LIGO PROJECT
 designed by **R. De Salvo**
 drawn by **G. Gennaro-PROMECH**
 date **20-12-04** scale **1/2**
HAM-OPTICAL BENCH
 DETAILS BASE
 drawing number **LIGO-D051115-01-D**
 sheet number **114** of **A 1**

1.2

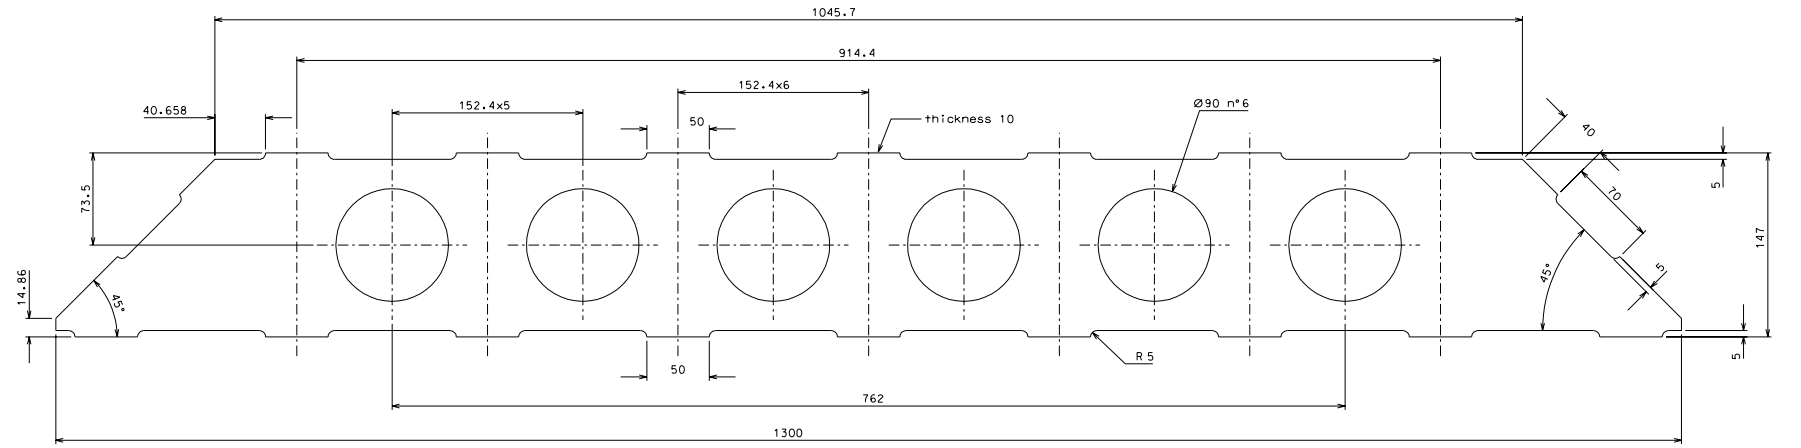
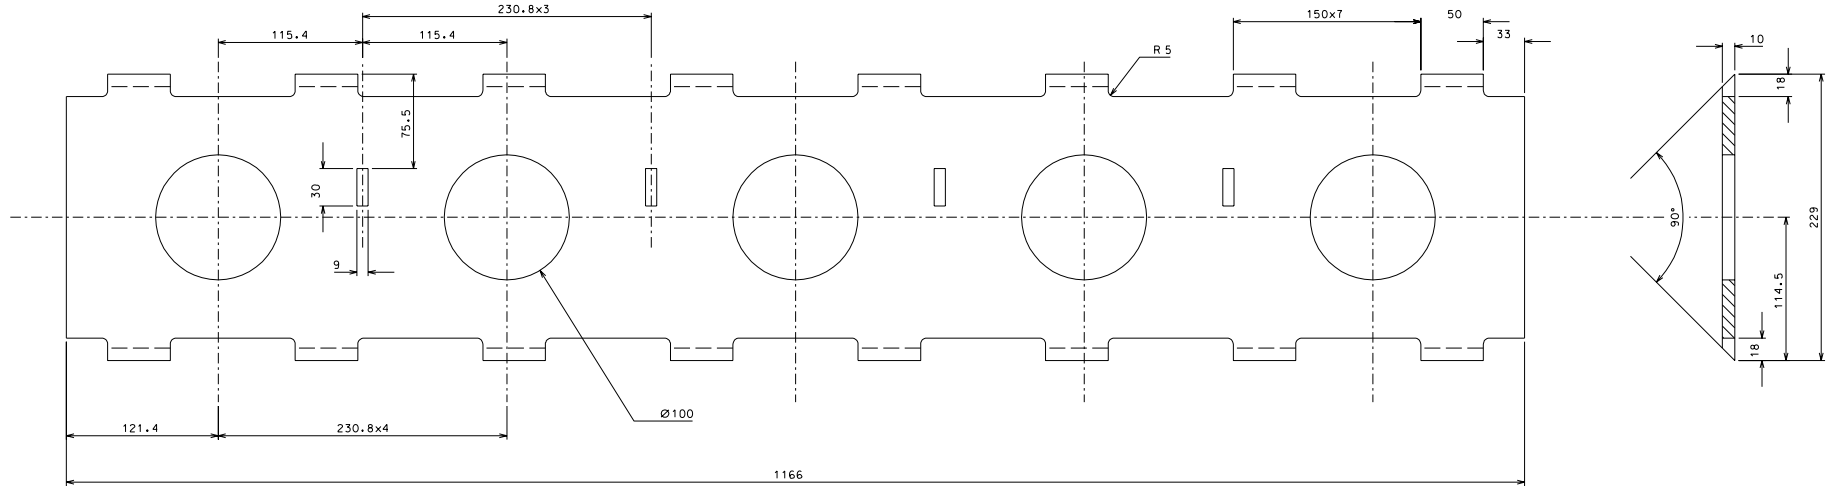
modified edge of part 1.2	04-05-06		
ref.	date	signature	
modifications
